C-17 LANDING-GEAR DURABILITY AND PARTS SUPPORT

Report No. 99-193

#### SUBJECT: Audit Report on C-17 Landing-Gear Durability and Parts Support (Report No. 99-193)

### C-17 Landing-Gear Durability and Parts Support

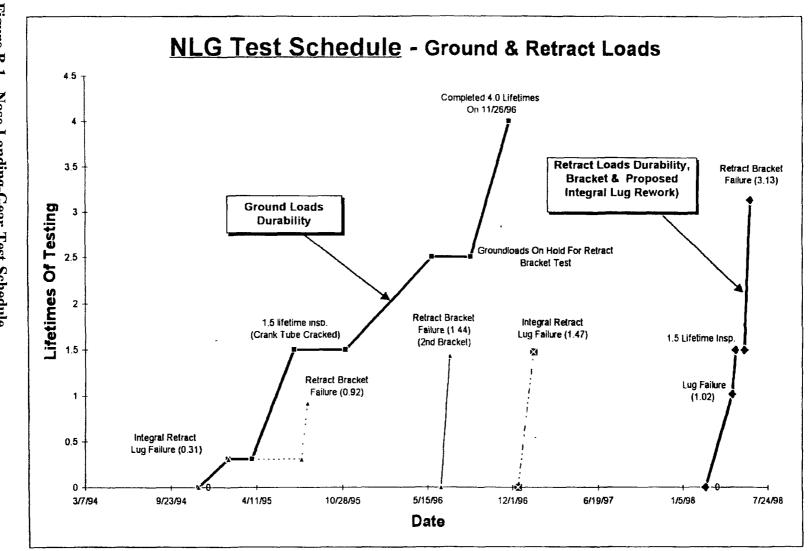
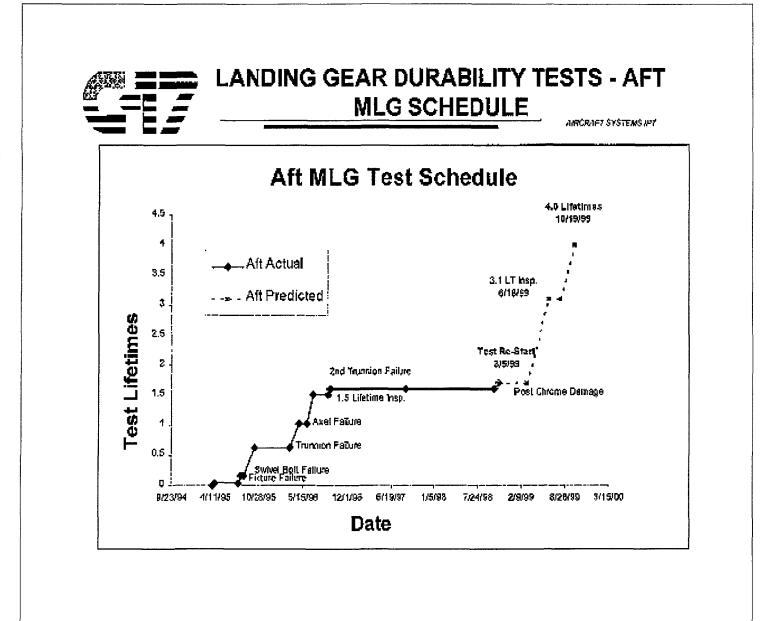
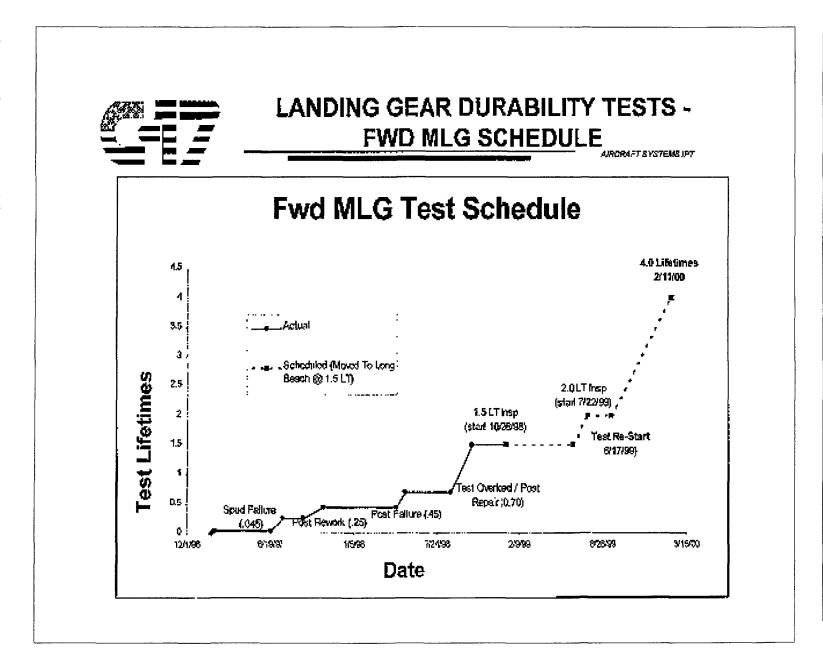
The forward and aft main landing-gear trunnion collars had repeated failures during durability testing, as shown in Figures B-2 and B-3. The trunnion collar and post are depicted in Figure B-4.

The forward main landing-gear trunnion failed at 0.045 lifetimes of test and was subsequently redesigned. The redesigned forward trunnion was installed in the test fixture, and testing resumed. Testing of the redesigned forward trunnion had reached 1.0 lifetimes in durability testing on October 21, 1998. Further testing of the forward trunnion will resume in the summer of 1999.

The aft main landing-gear trunnion collar failed at 0.63 lifetimes and was subsequently redesigned. The redesigned aft trunnion was installed in the test fixture, and testing resumed. The redesigned aft trunnion collar failed at 1.60 lifetimes. Accounting for the scatter factor of four, the failure corresponds to an actual life of 0.40. Testing of the aft landing gear was on hold for 2 years because of post redesign.

The main landing-gear posts experienced damage during early operations and failure during durability testing. The forward and aft main landing-gear posts were redesigned and are no longer interchangeable. As shown in Figure B-3, the forward main landing-gear post failed at 0.45 lifetimes of use. The failure corresponds to an actual life of 0.11. The contractor is responsible for the cost to redesign, produce, and retrofit up to 1.5 lifetimes. Therefore, we assumed that the forward landing-gear posts would, at contractor expense, eventually exhibit at least 1.5 lifetimes of durability testing. If the contractor is not able to extend the life of the forward main landing-gear post through redesign past 1.5 lifetimes and the trunnion is declared life-limited, the Government would be responsible for the cost of production and retrofit. At 1.5 lifetimes of durability, each forward landing-gear post would then have to be replaced every 0.38 (1.5/4.0) lifetimes of use, corresponding to no more than three forward landing-gear posts used over the life of the aircraft. Each aircraft has two forward main landing-gear posts. The cost per forward main landing-gear post is \$277,536. The cost to replace two forward main landing-gear posts twice over the life of the aircraft would be \$1,110,144. Therefore, the government's cost to replace the forward main landing gear for the fleet of 120 aircraft over the life of the fleet would be approximately \$133.2 million.
